VIRGINIA ELECTRIC AND POWER COMPANY
RICHMOND, VIRGINIA 23261

TOPICAL REPORT VEP-FRD-33
"VEPCO REACTOR CORE THERMAL-HYDRAULIC ANALYSIS
USING THE COBRA IIIC/MIT COMPUTER CODE"

ATTACHMENT 1

Response to NRC Questions on VEP-FRD-33

FIGURE 1

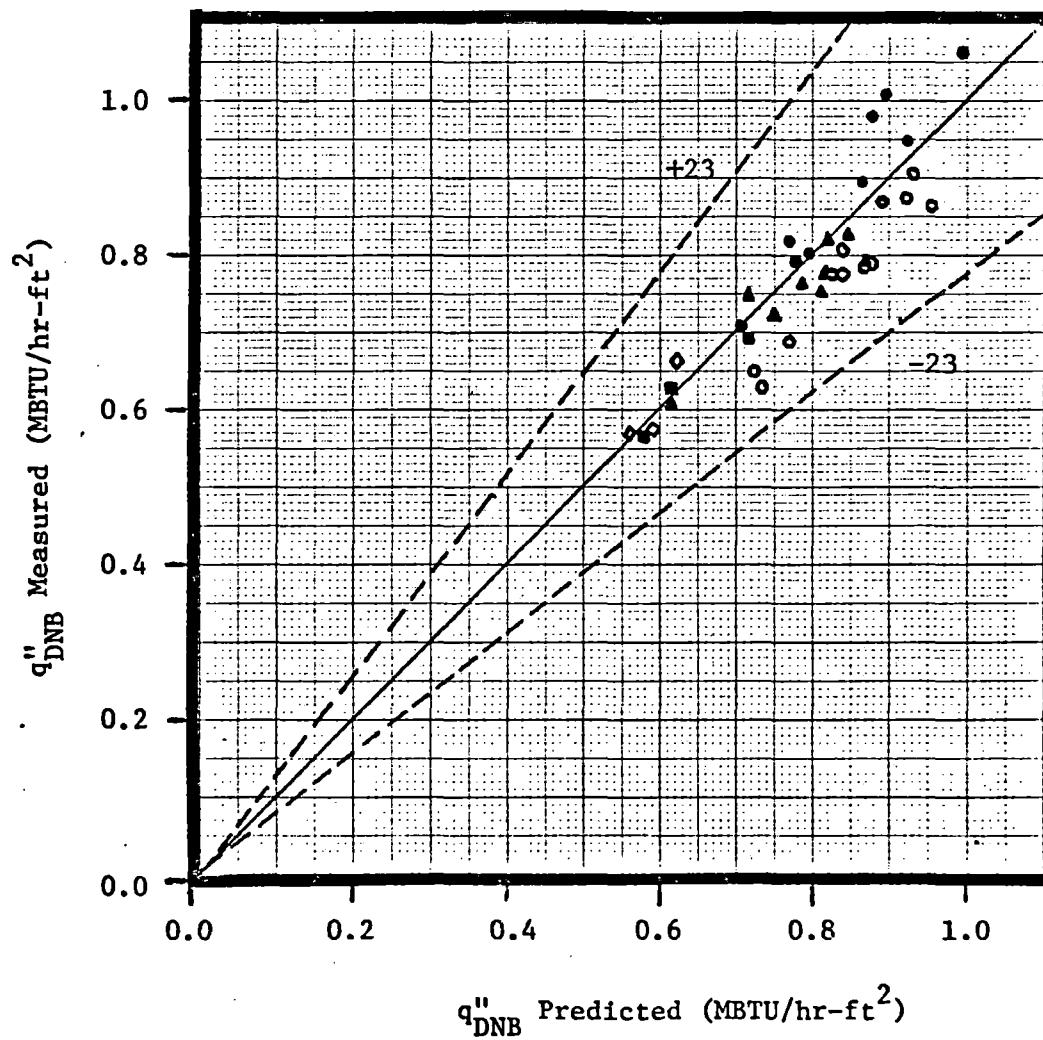
NRC Question 492.1

"Provide CHF predictions (plots and tables) versus the measured values for the test data (Ref. 1) using VEP-FRD-33 COBRA/W-3. Include at least two points from each set of tests in the Ref. 1 test data such that your test conditions will be similar to the limiting thermal-hydraulic operating conditions for Surry Units 1 and 2 and North Anna Units."

COBRA models of the Ref. 1 3x3 and 4x4 test bundle geometries were created using code correlations and options consistent with VEP-FRD-33. Three data points from each test series were chosen such that the range of key test parameters would be maximized. The data ranges are given in Table I. The North Anna and Surry allowable operating conditions are well within these ranges. A comparison of the COBRA/W-3 DNB predictions and the experimental DNB data is given in Table II. These results are presented graphically in Figure 1. The sample mean and standard deviation of the measured-to-predicted heat flux ratio are 0.982 and 0.0638, respectively. These limited data indicate that in order to meet a 95% probability/95% confidence level reactor design criteria, a minimum DNBR of 1.19 would be required. VEPCO intends

to continue using the 1.30 minimum DNBR design criteria established by the original W-3 correlation data. These original W-3 correlation bounds are also indicated on Figure 1. Should we desire to use a minimum DNBR design basis other than 1.30, additional justification would be provided.
